SENDLEWSKI ARCHITECTS, PC
ARCHITECTS – PLANNERS

ADDENDUM NO. 1
ISSUED 08-15-22

FIREHOUSE FACILITY PROJECTS
TAPPAN FIRE DISTRICT
PROJECT No. 2108.01A, 2108.01B, 2108.02

FOUNDATION PLAN

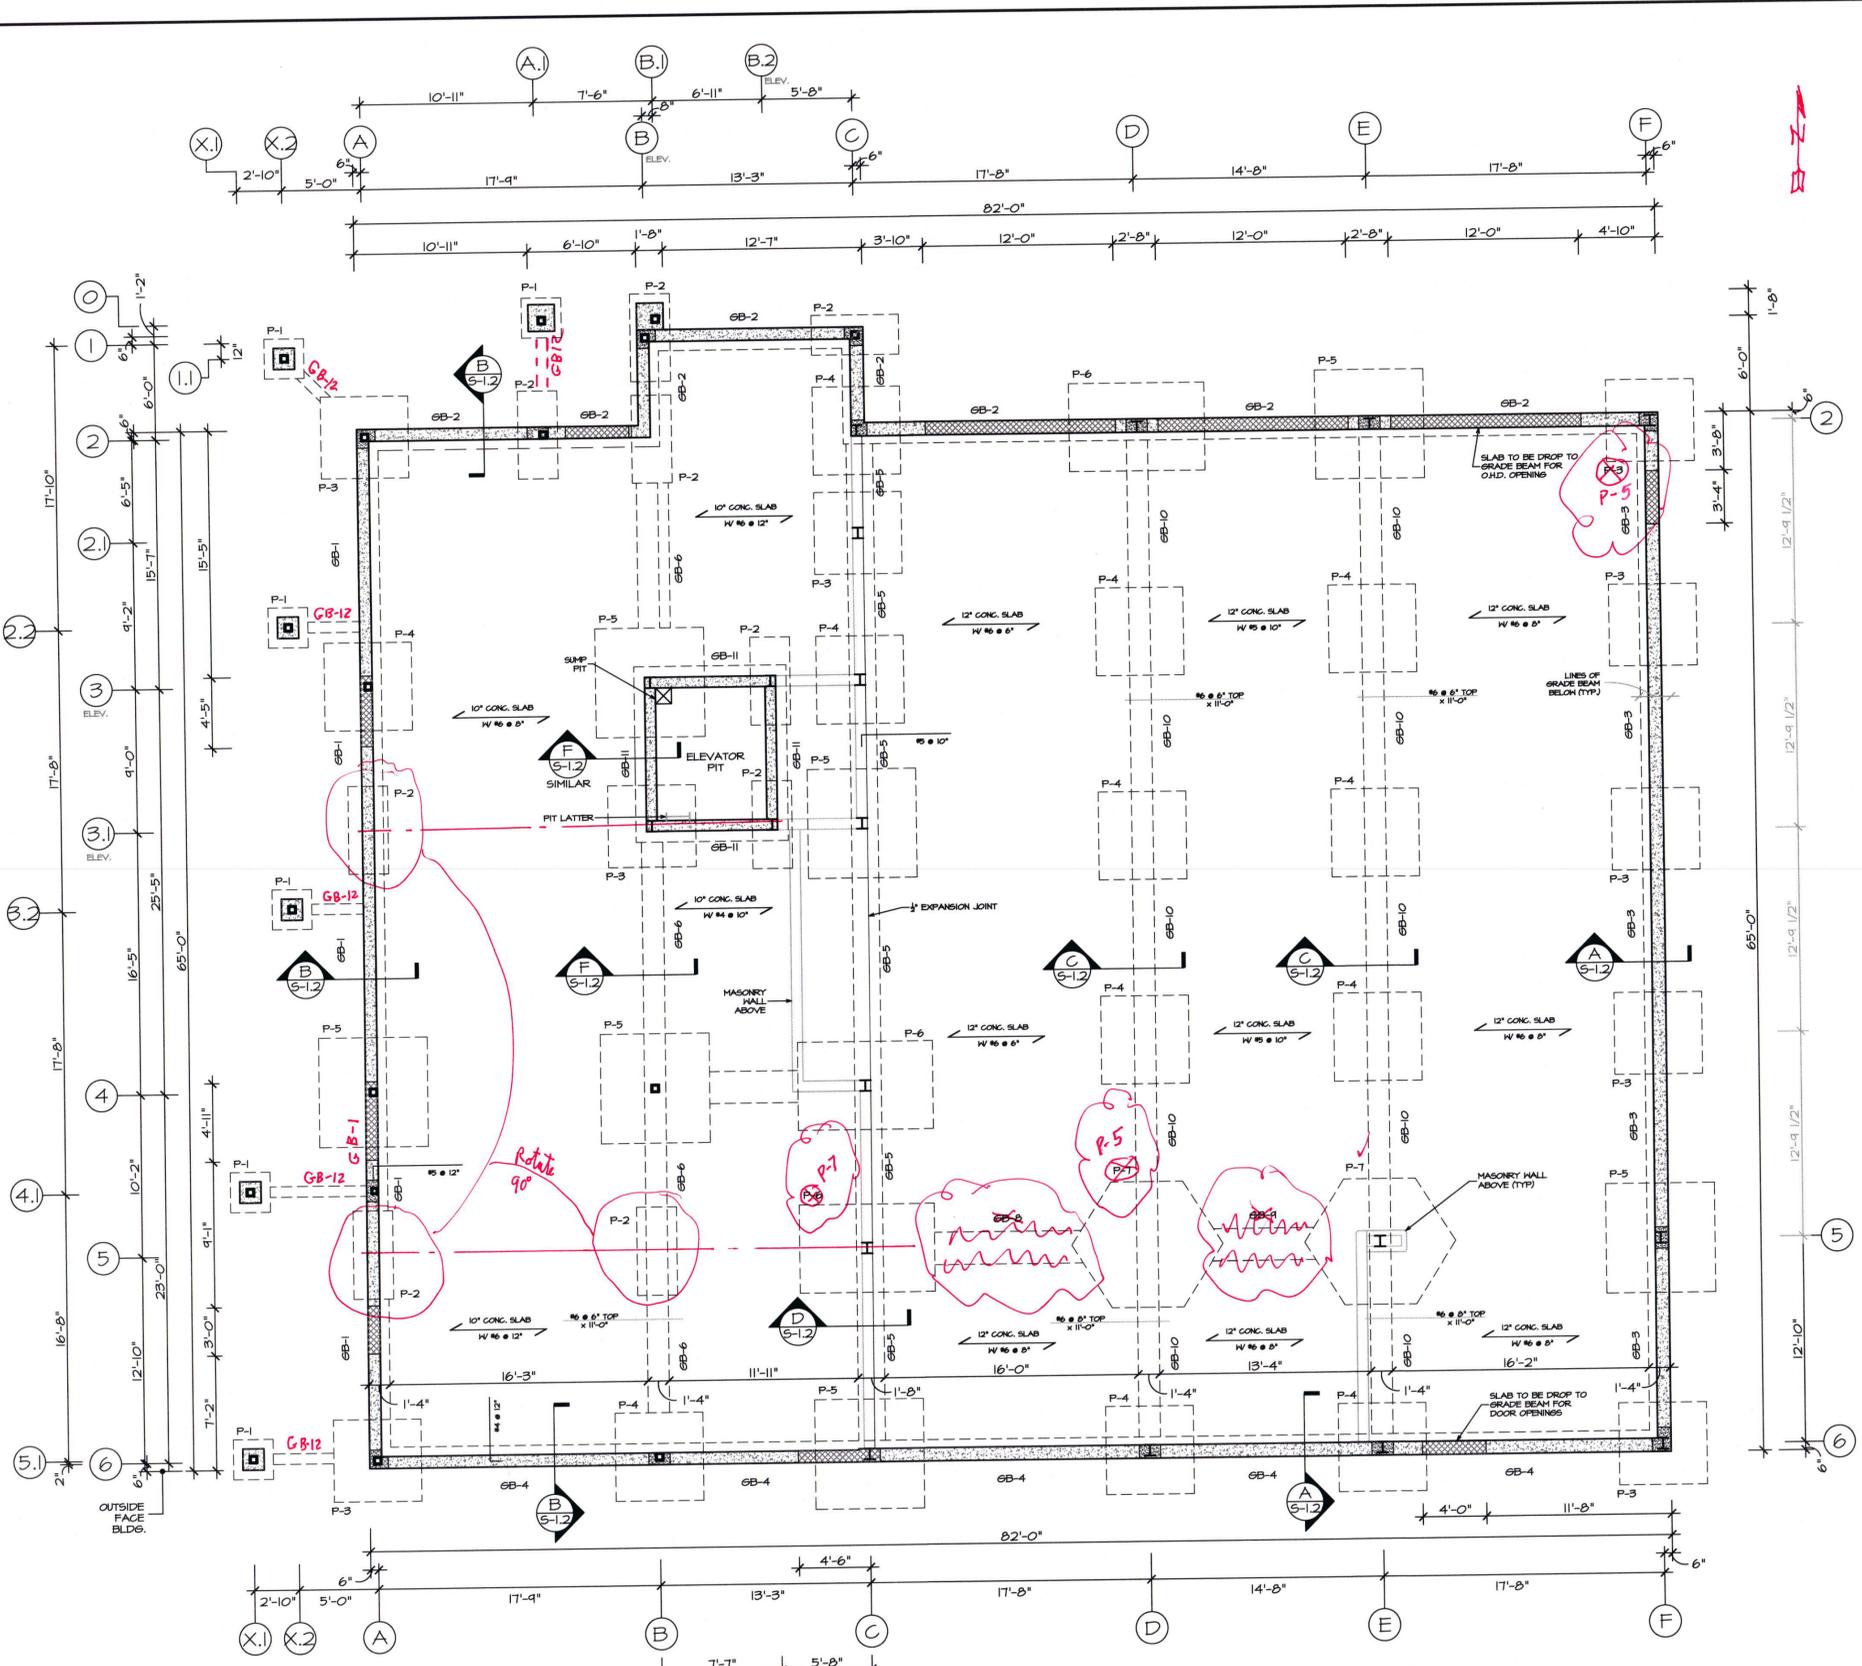
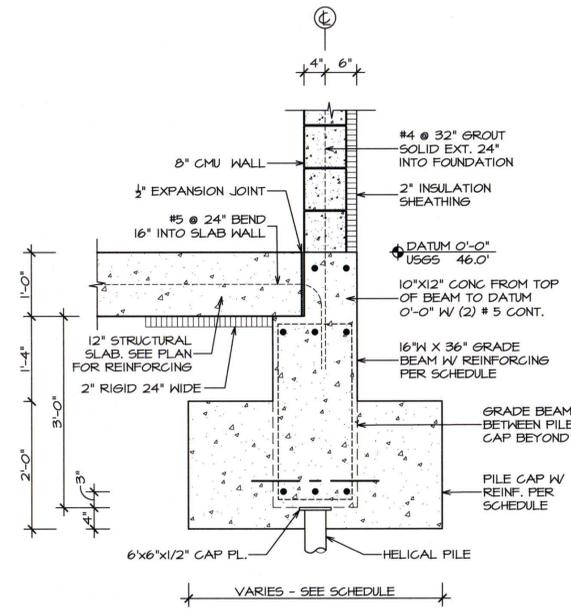
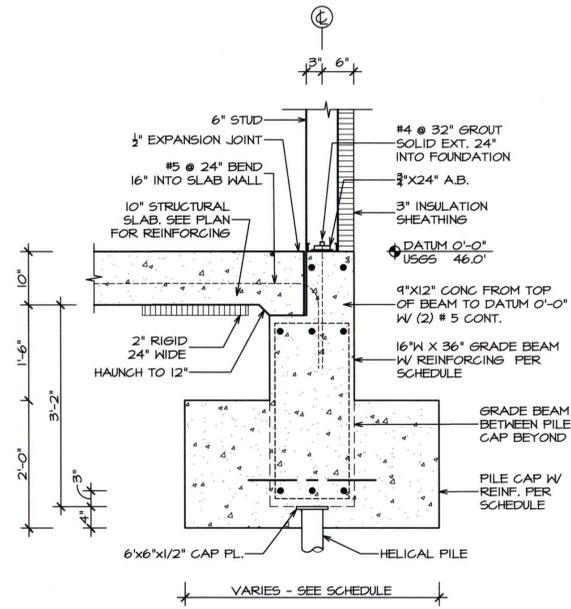
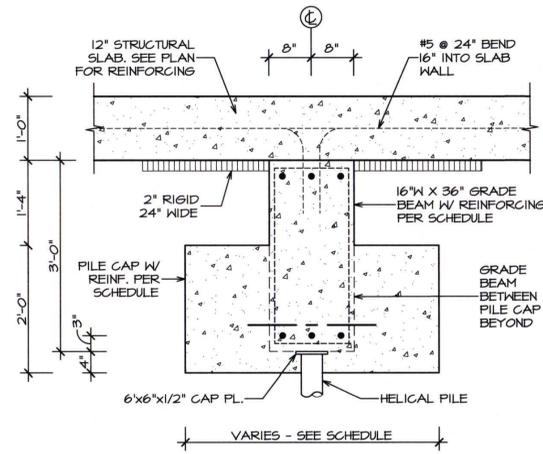
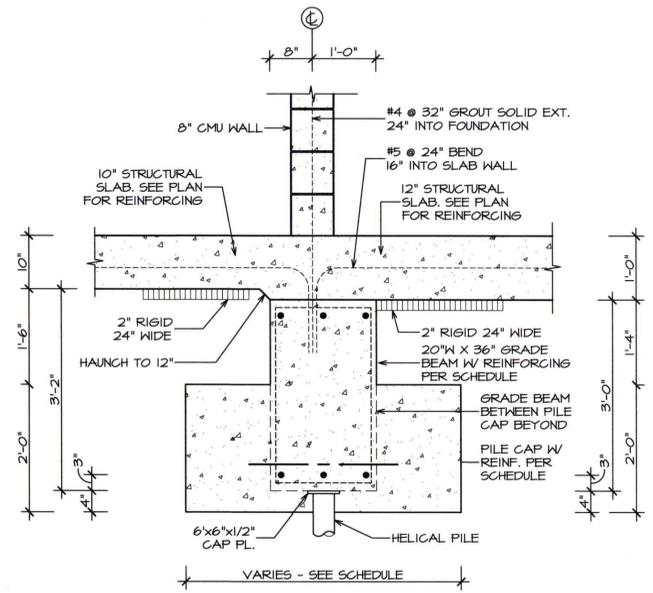
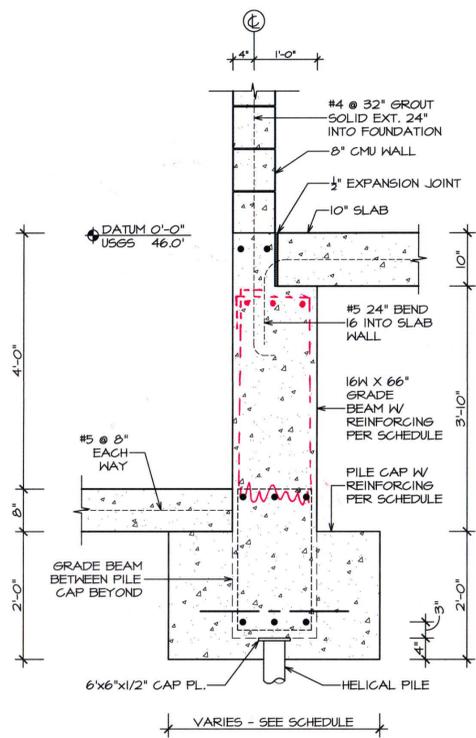
- **A-6.2** – Changes made to Wall Section 'B'.
 - **S-1.1** – Changes made to Foundation Plan, Pile Cap Details, and Grade Beam Schedule.
 - **S-1.2** – Changes made to Detail 'E'.

FOUNDATION PIER DETAILS

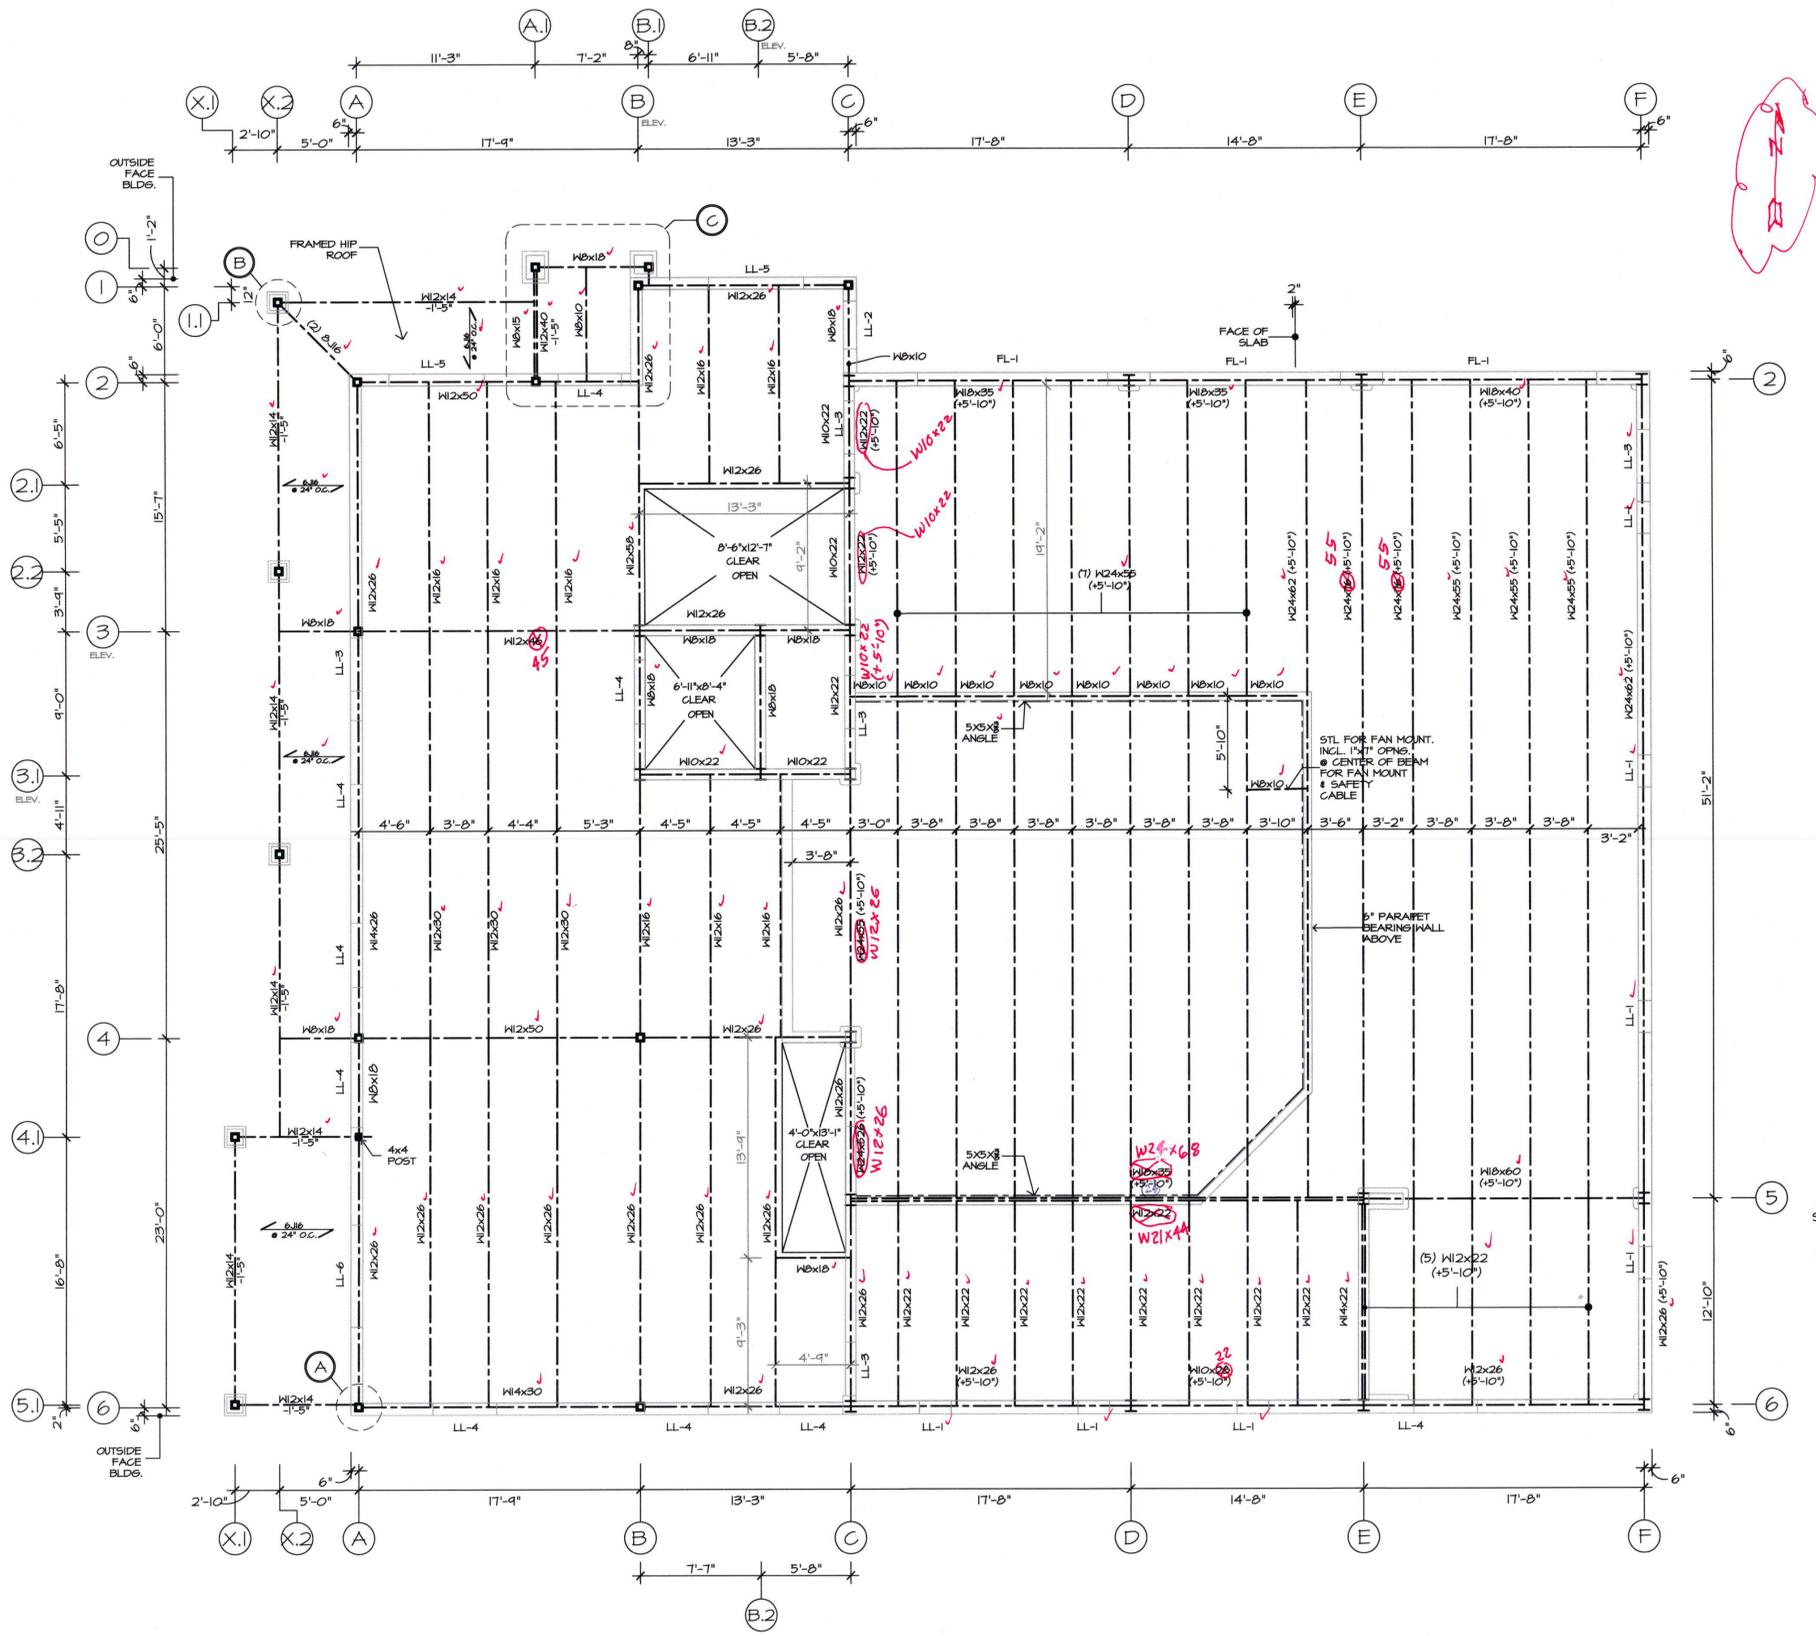
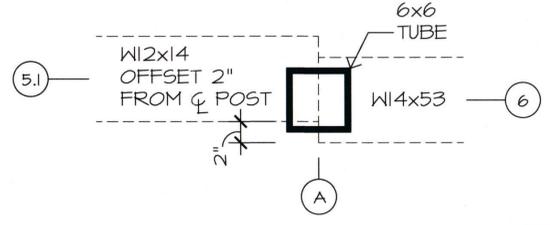
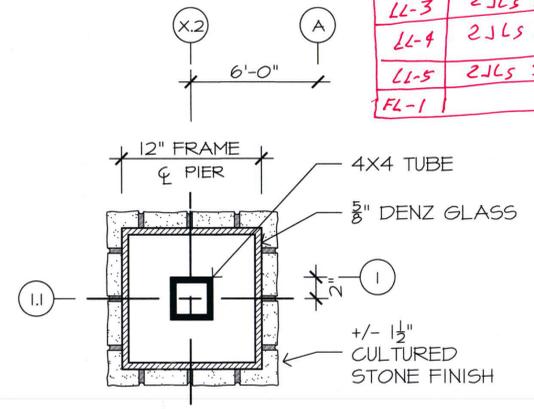
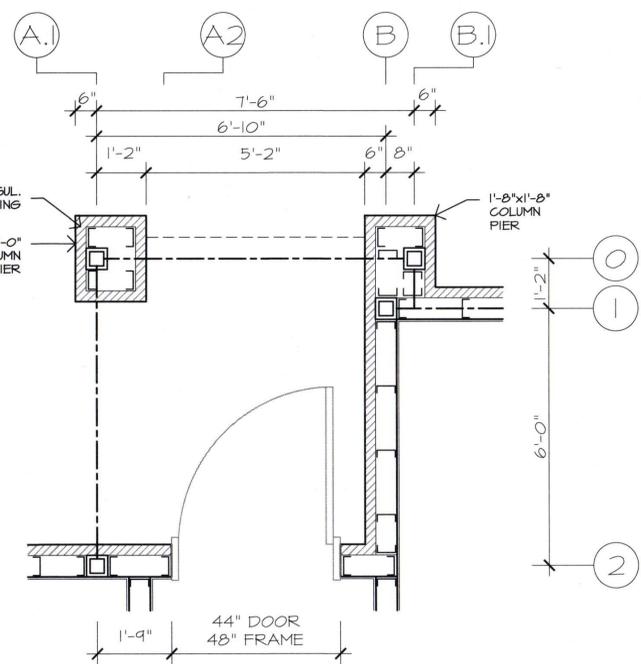
- **S-2** – Changes made to Second Floor Framing Plan, and Lintel Schedule added.
 - **S-4** – Changes made to Column Schedule.
